**BCTS TA0132 Mud Lake
Visual Assessment
& Design Recommendations
RDI Resource Design Inc
November 21, 2019 Final Layout**

Introduction

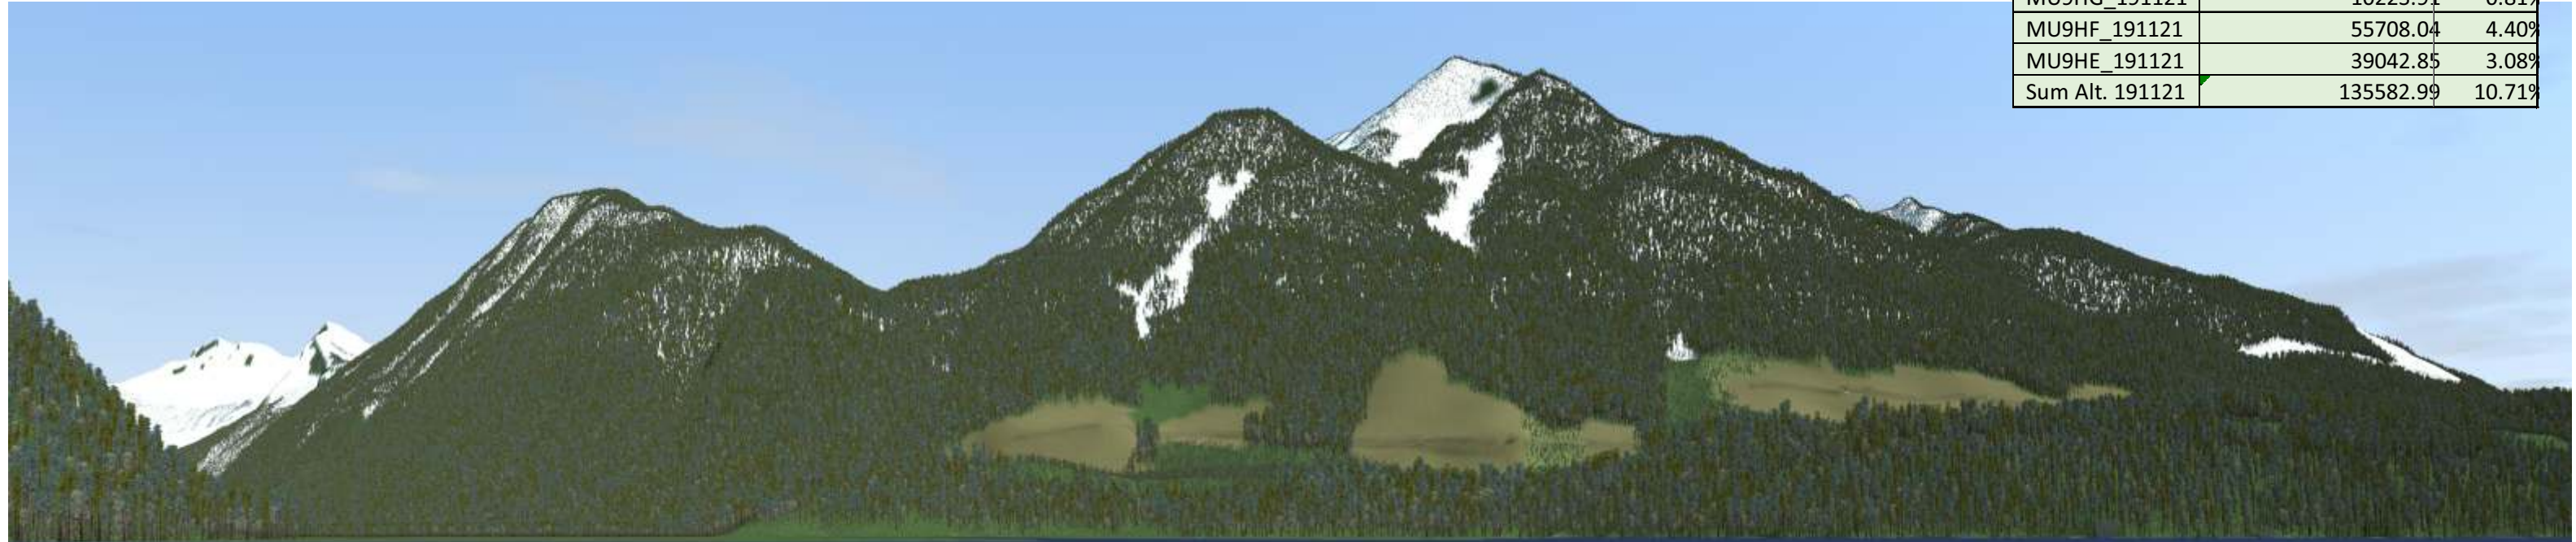
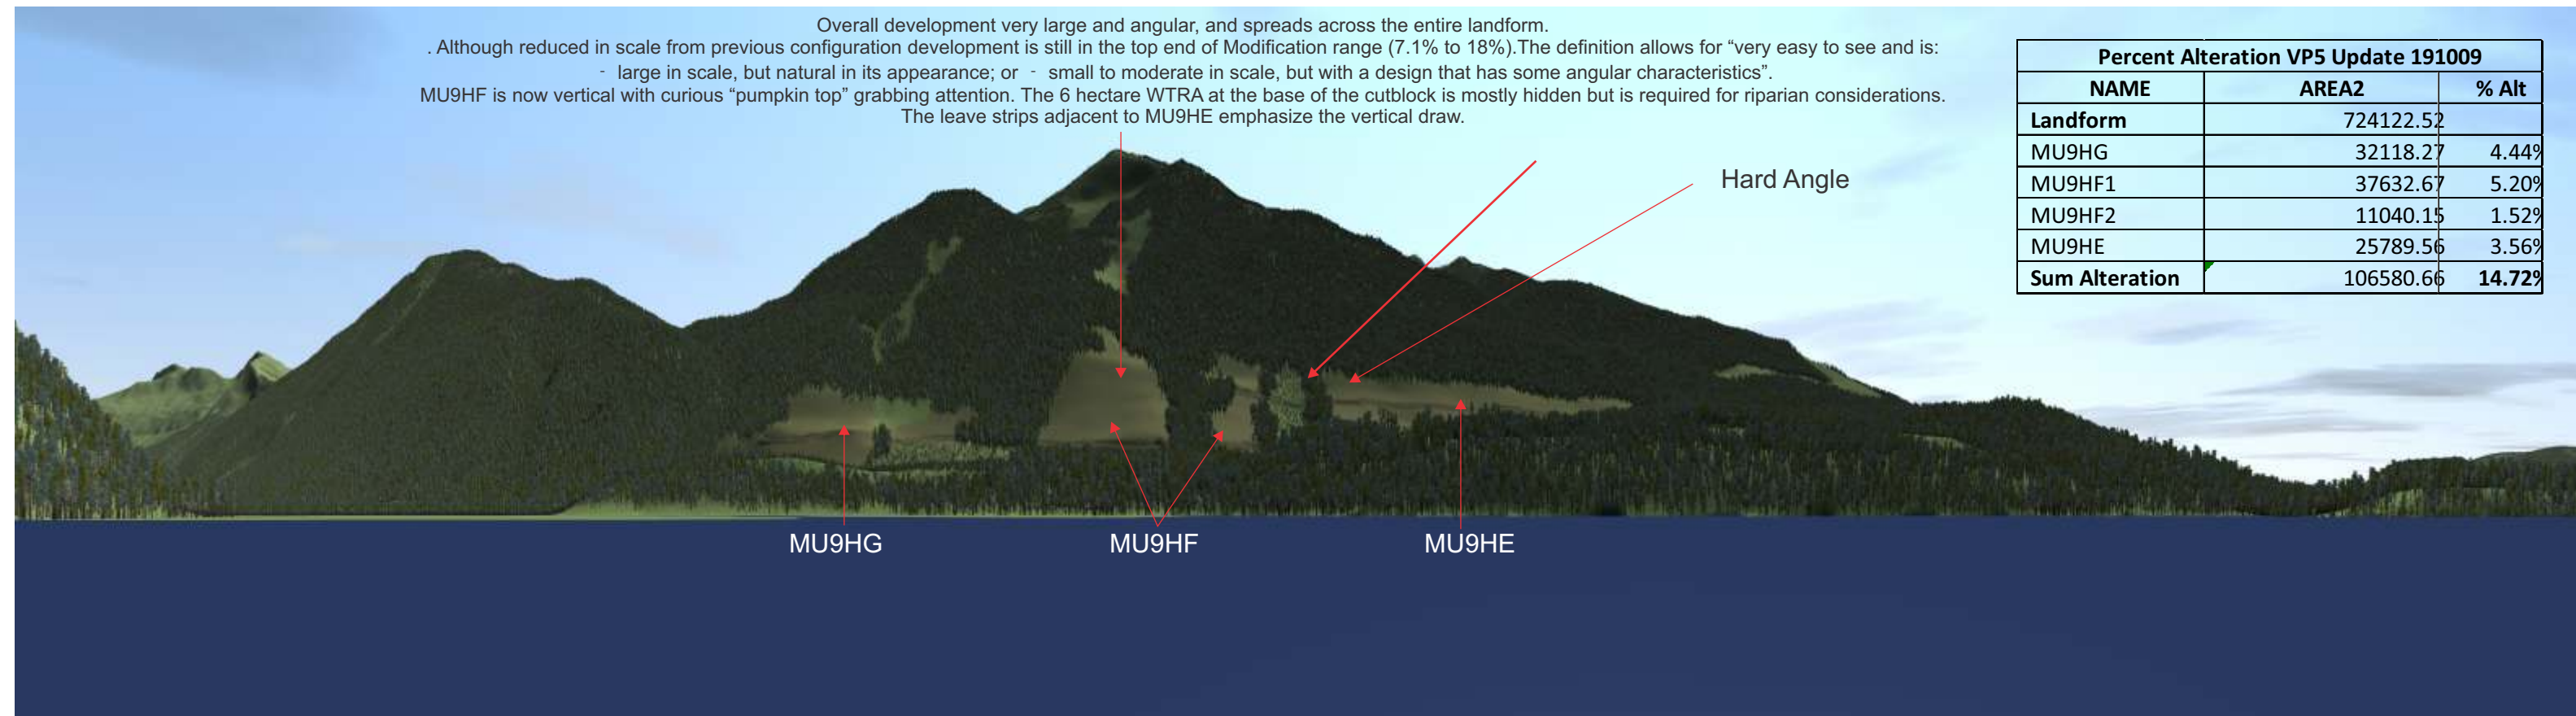
Overall development very large and angular, and spreads across the entire landform.
 . Although reduced in scale from previous configuration development is still in the top end of Modification range (7.1% to 18%). The definition allows for "very easy to see and is:
 - large in scale, but natural in its appearance; or - small to moderate in scale, but with a design that has some angular characteristics".
 MU9HF is now vertical with curious "pumpkin top" grabbing attention. The 6 hectare WTRA at the base of the cutblock is mostly hidden but is required for riparian considerations.
 The leave strips adjacent to MU9HE emphasize the vertical draw.
